HERITAGE IMPACT ASSESSMENT OF 441 ECHO DRIVE, OTTAWA

MAY 7, 2026 JUXTA
PROJECT NO. 2541

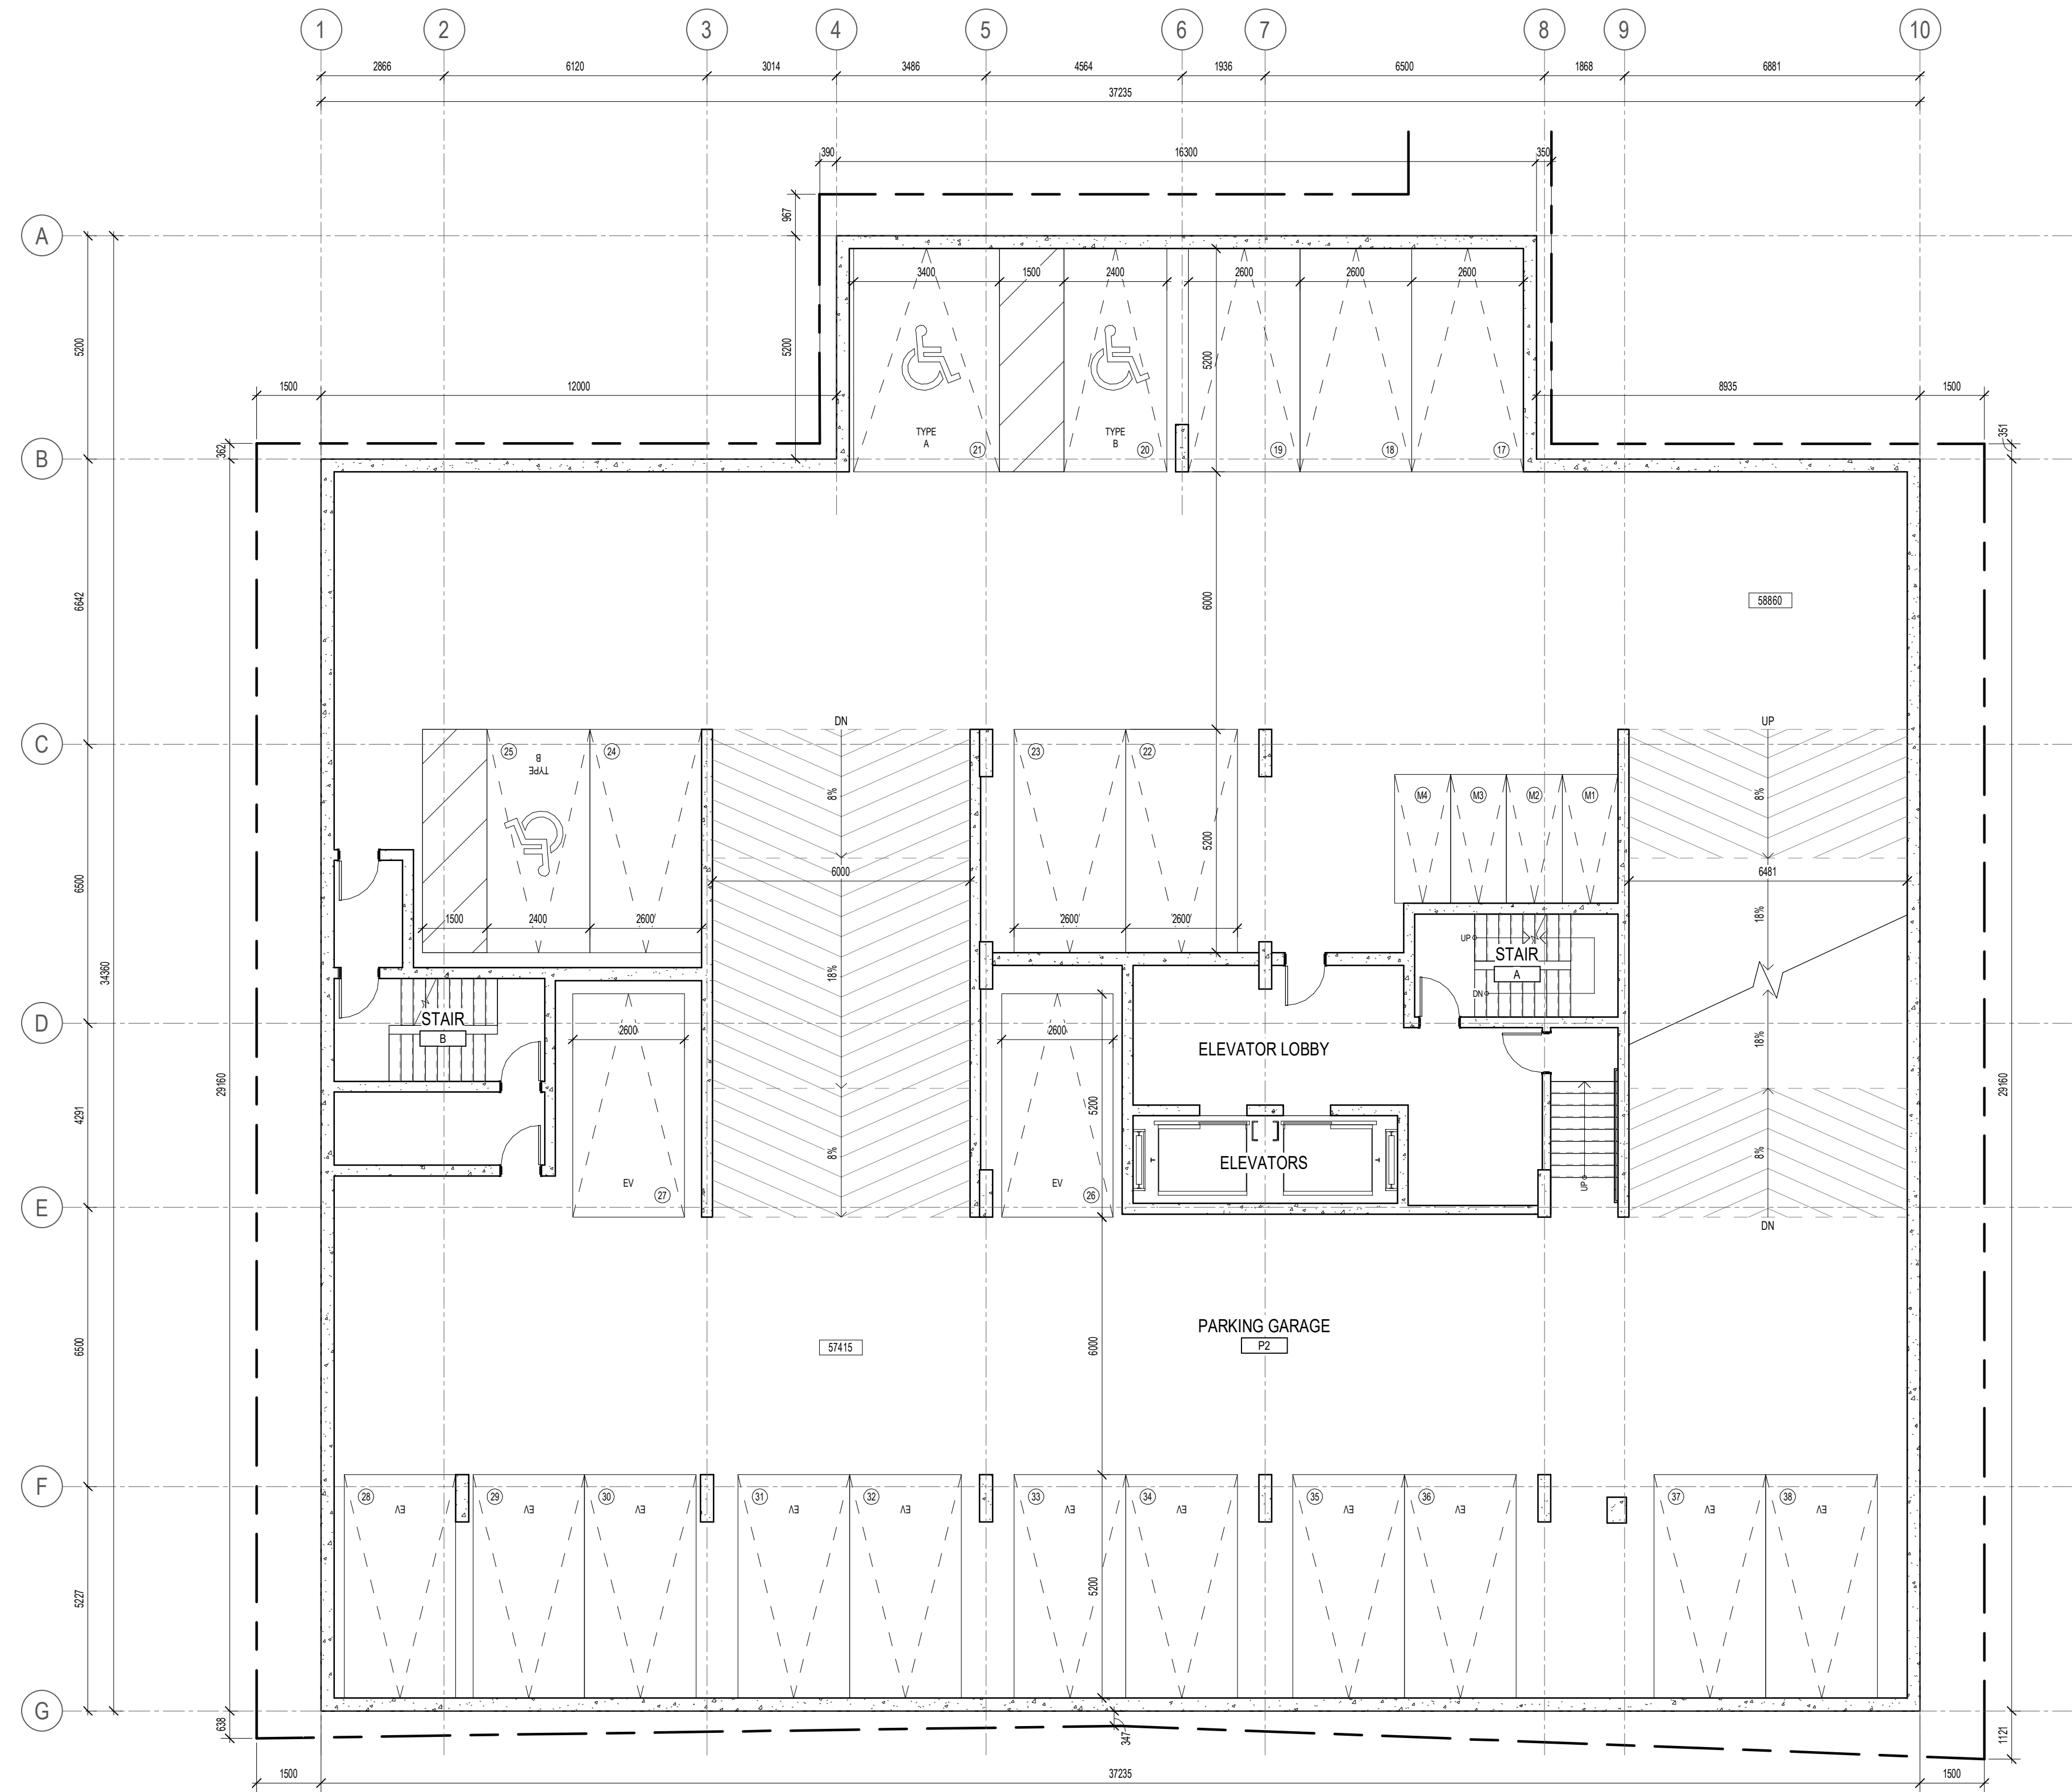
- Drawings are not to be scaled. The Contractor is responsible for checking and verifying all levels and dimensions and shall report all discrepancies to the Architect and obtain clarification prior to commencing work.

- Upon notice in writing, the Architect will provide written graphic clarification or supplementary information regarding the intent of the Contract Documents.

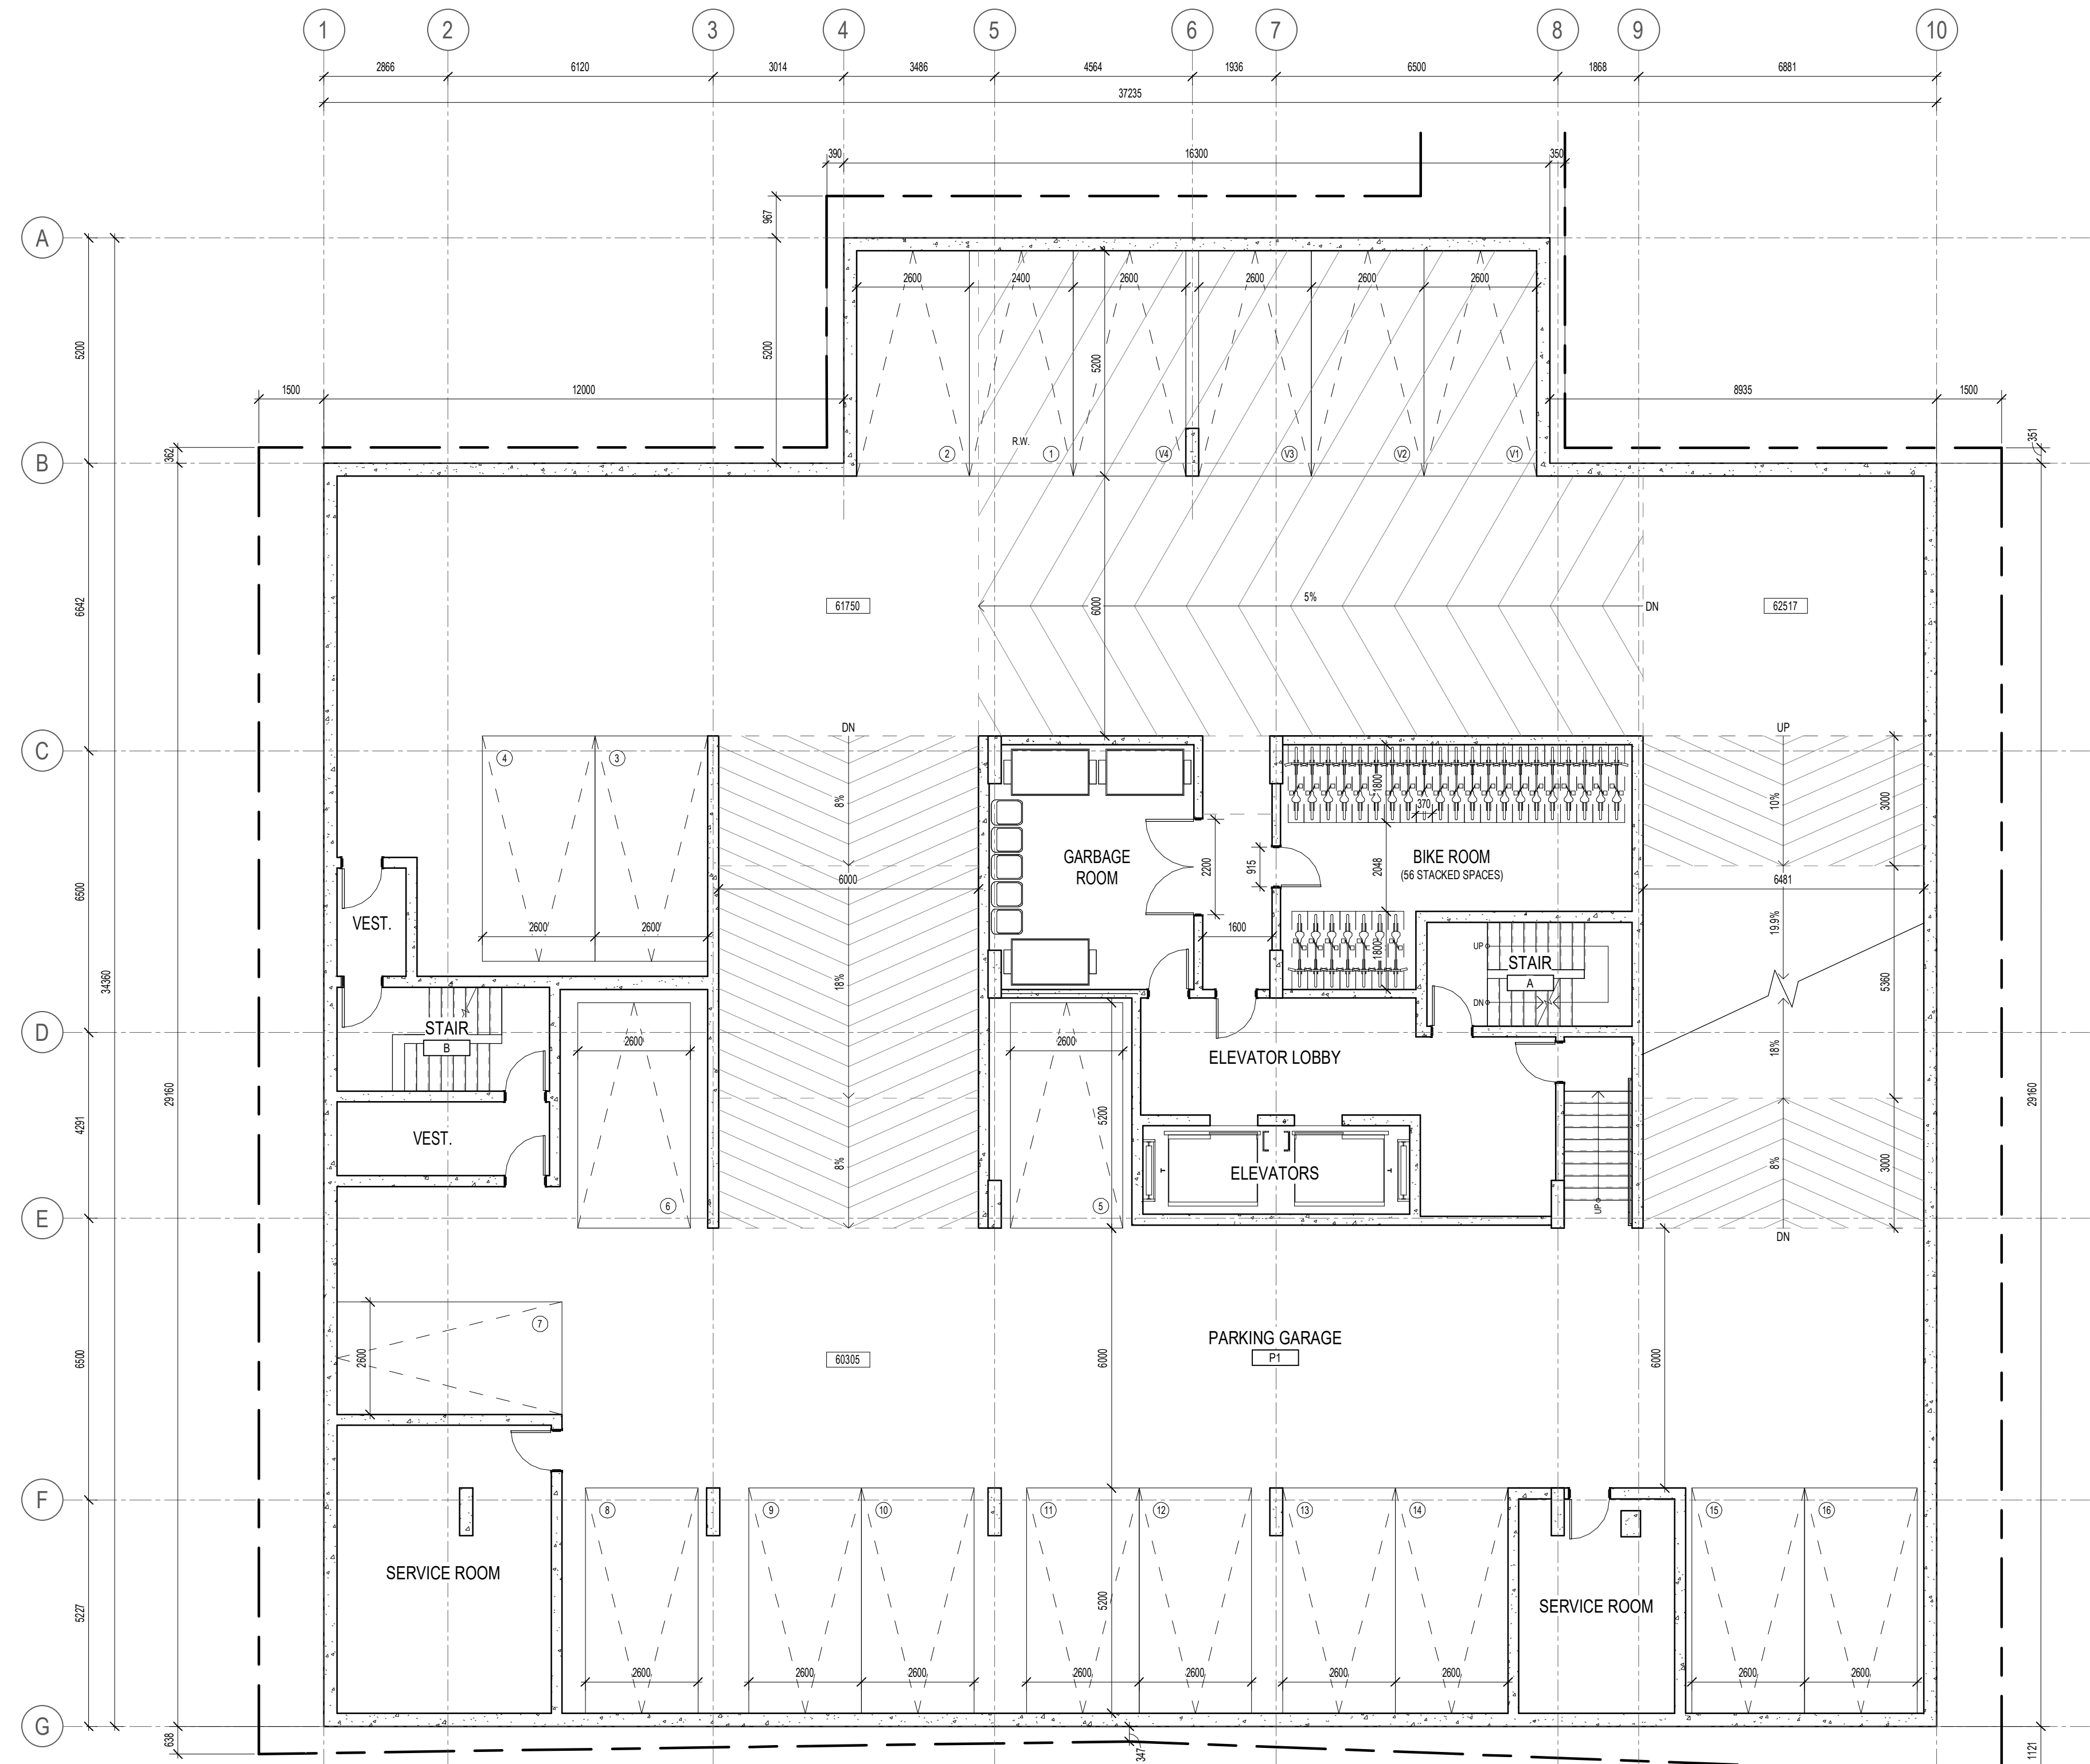
- Drawings are not to be scaled. The Contractor is responsible for checking and verifying all levels and dimensions and shall report all discrepancies to the Architect and obtain clarification prior to commencing work.

- Upon notice in writing, the Architect will provide written graphic clarification or supplementary information regarding the intent of the Contract Documents.

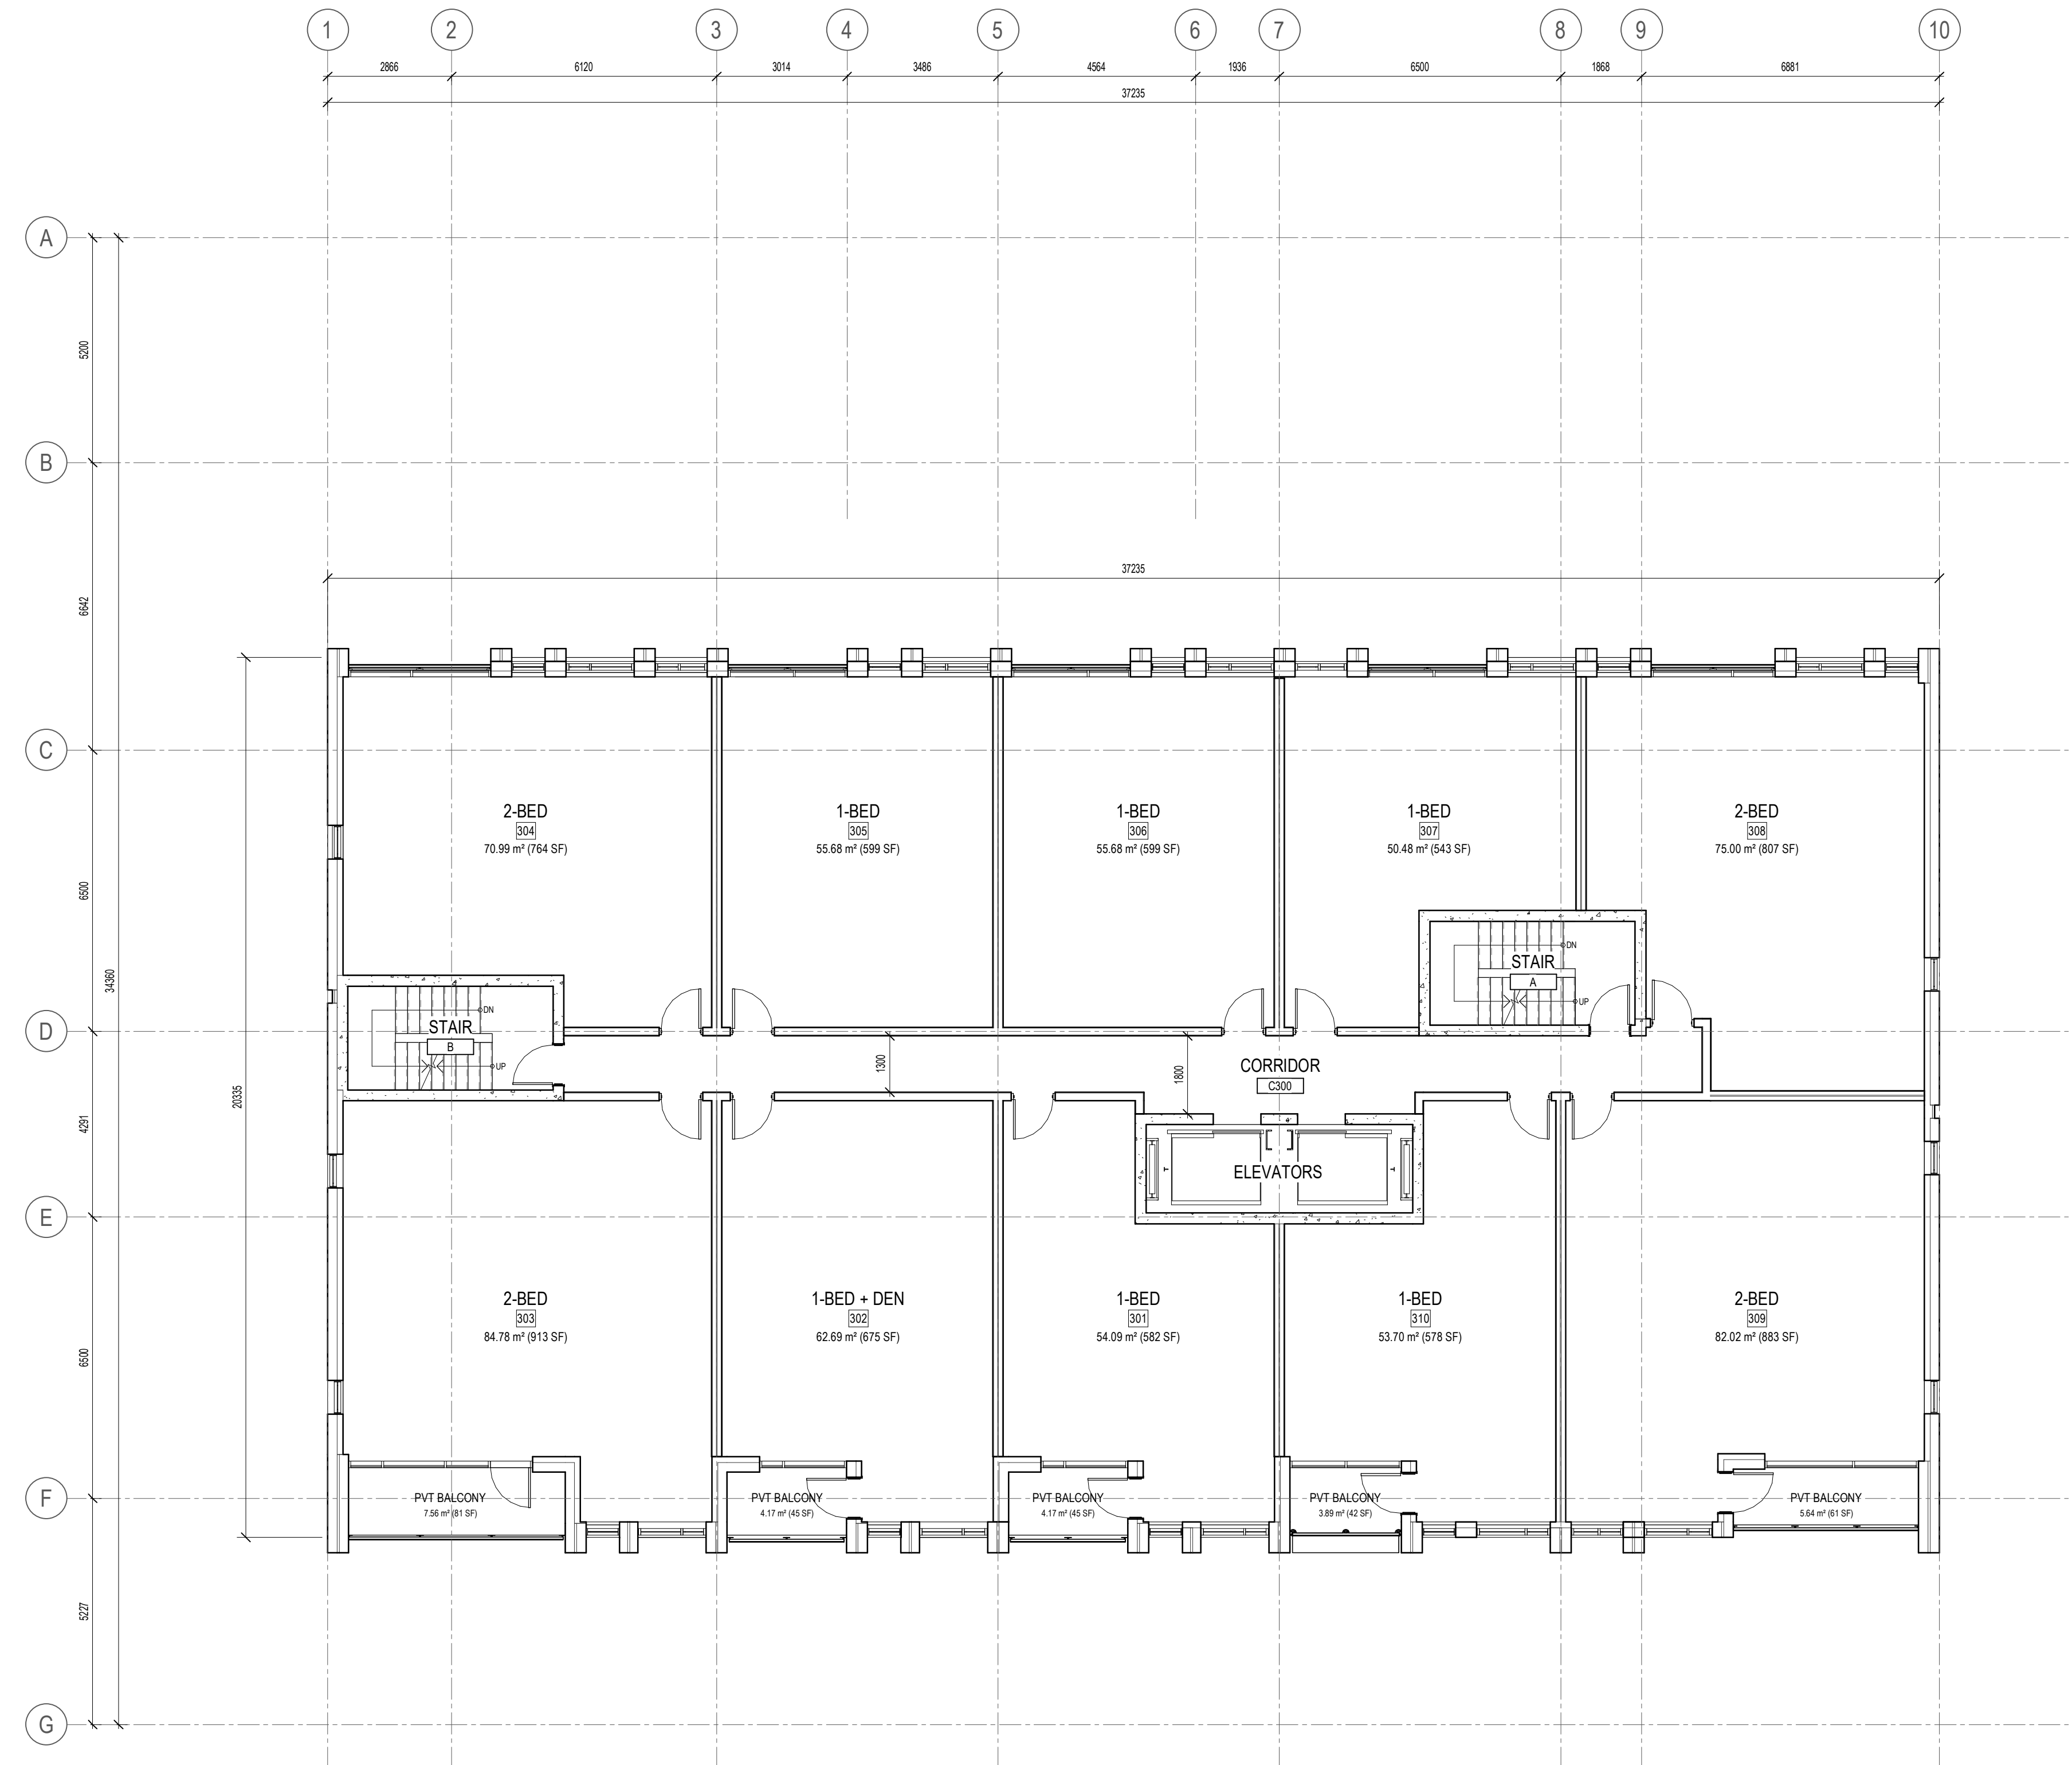
- Drawings are not to be scaled. The Contractor is responsible for checking and verifying all levels and dimensions and shall report all discrepancies to the Architect and obtain clarification prior to commencing work.

- Upon notice in writing, the Architect will provide written graphic clarification or supplementary information regarding the intent of the Contract Documents.
